Access Compliance Report

Public Rights-of-Way

Intersection ID: N/A	Main Street: BROOKSVALE_ST	Cross Street: BURNETTE_AV	Location: NE
ADA ID: C7D0604A5A6B	Ramp Type: Perp	Initial Pass/Fail: Fail	Overall Compliance: No
		Severity Score: 12.5

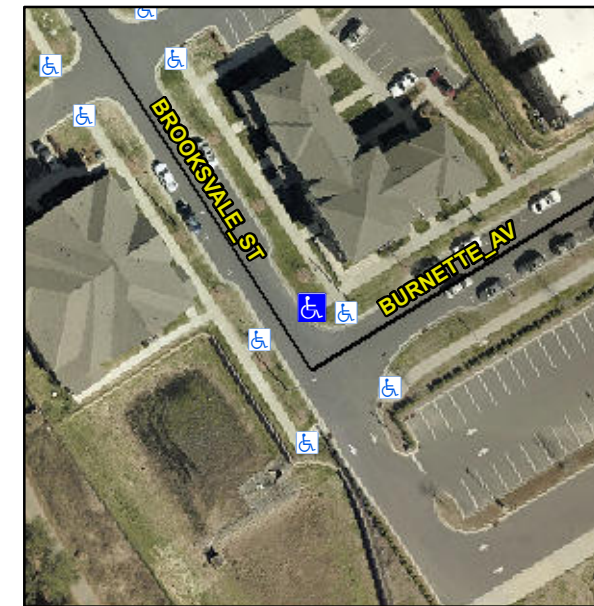
Not Found, R304.2.2

Compliance	Description	Data	Compliance	Description	Data
N/A	Ramp Length (in)	73.0	No	Ramp Slope (%)	8.6
Yes	Ramp Width (in)	70.0	Yes	Ramp XSlope (%)	0.1
N/A	Flare Type LT	N/A	N/A	Flare Type RT	N/A
N/A	Flare Slope LT (%)	N/A	N/A	Flare Slope RT (%)	N/A
N/A	Flare Traversable LT?	N/A	N/A	Flare Traversable RT?	N/A
N/A	Landing Length (in)	N/A	N/A	DWS Provided?	N/A
N/A	Landing Width (in)	N/A	N/A	DWS Contrast?	N/A
N/A	Landing Slope (%)	N/A	N/A	DWS Length (in)	N/A
N/A	Landing X Slope (%)	N/A	N/A	DWS Full Width?	N/A
N/A	Landing Curb? (Y/N)	N/A	N/A	DWS Offset (in)	N/A
N/A	Shared Landing?	N/A			
N/A	Gutter Ponding?	N/A	N/A	Gutter Slope (%)	N/A
N/A	Gutter Lip Ht (in)	N/A	N/A	Gutter X Slope (%)	N/A
N/A	Painted X Walk1?	No	N/A	Painted X Walk2?	N/A
	X Walk 1 Direction	To SW		X Walk 2 Direction	N/A
N/A	X Walk 1 Width (in)	N/A	N/A	X Walk 2 Width (in)	N/A
	X Walk 1 Slope (%)	0.8		X Walk 2 Slope (%)	N/A
	X Walk 1 X Slope (%)	0.2		X Walk 2 X Slope (%)	N/A

Remove & Replace Entire Ramp.
